Project | B23320 | Heyrman Residence Garage Addition

Subject | WDADAR23-0010 DADAR - 16185 N Timberline Drive: Revised Floor Plan per Article 306.25

HEYRMAN RESIDENCE DETACHED GARAGE

ELEVATIONS
 NORTH/SOUTH

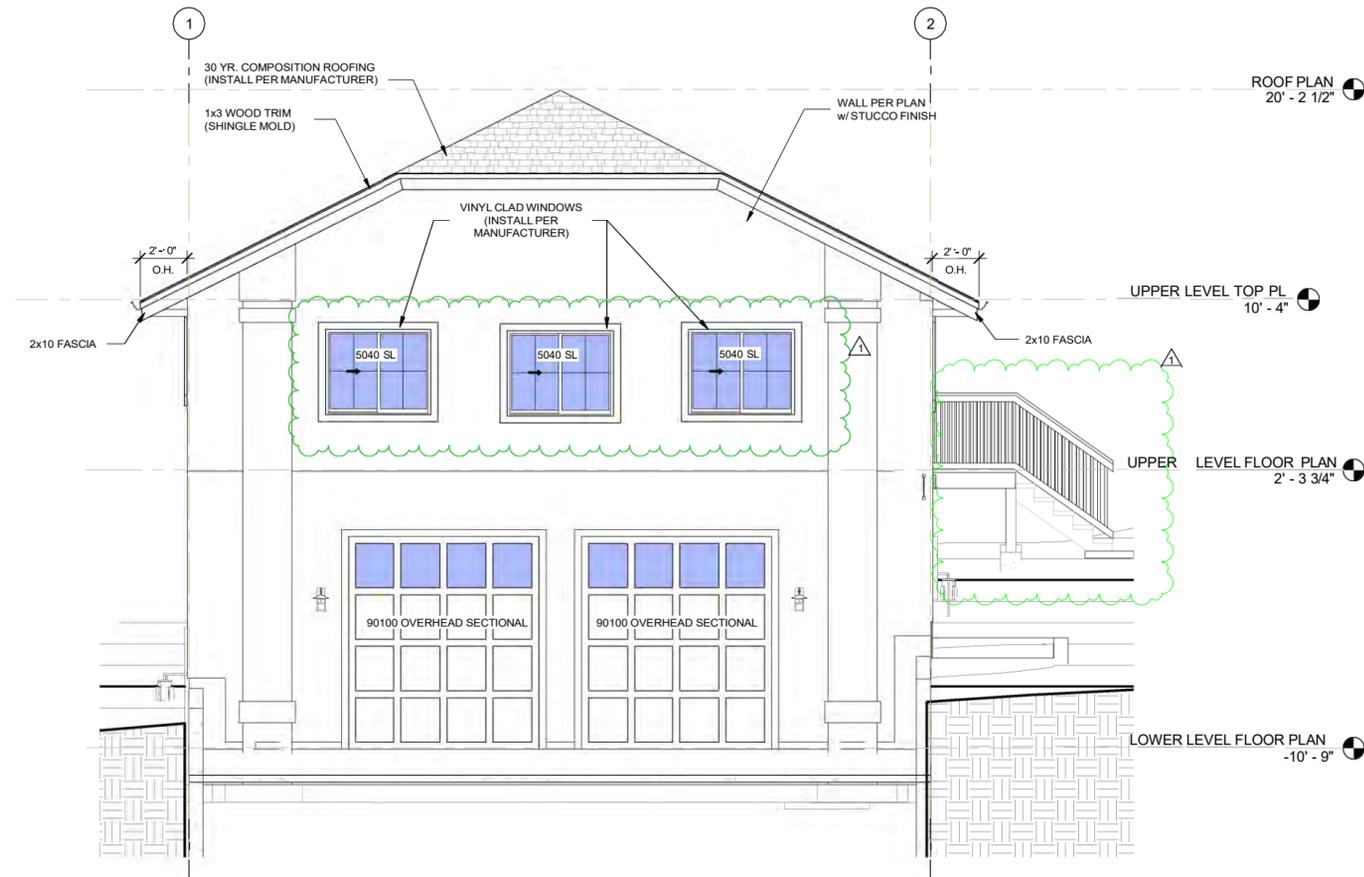
- 7) The sections, elevations, and electrical plans have been updated as needed for the floor plan changes. Refer to Sheets A1.3 through A1.6.

FOUNDATION PLAN

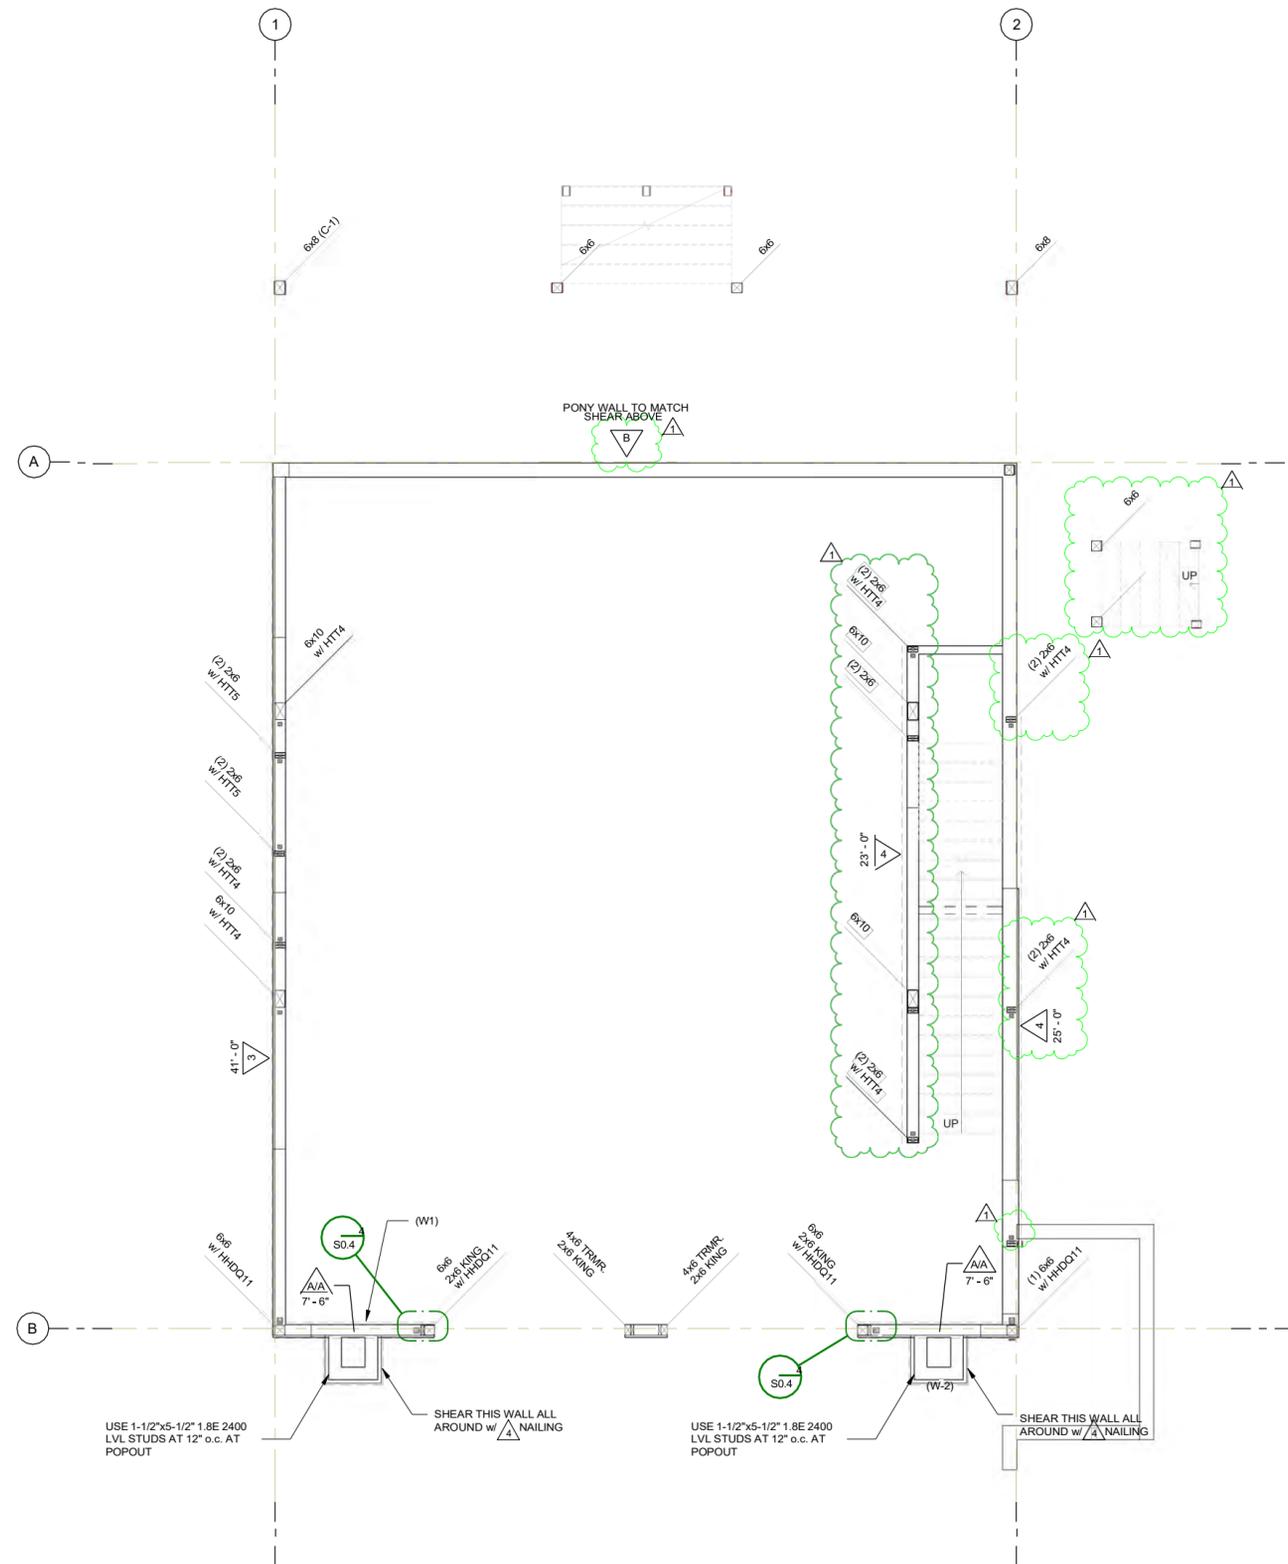
- 4) The master bedroom and bathroom layout, kitchen layout, and living area have been updated. Refer to Sheet A1.1.
- 5) The framing plans, structural plans, and foundation plan have been revised according to the updated calculations in accordance to the changes made to the architectural plans. Refer to Sheets S1.1, S1.2, S2.2, and S2.3 along with the revised Structural Calculations.
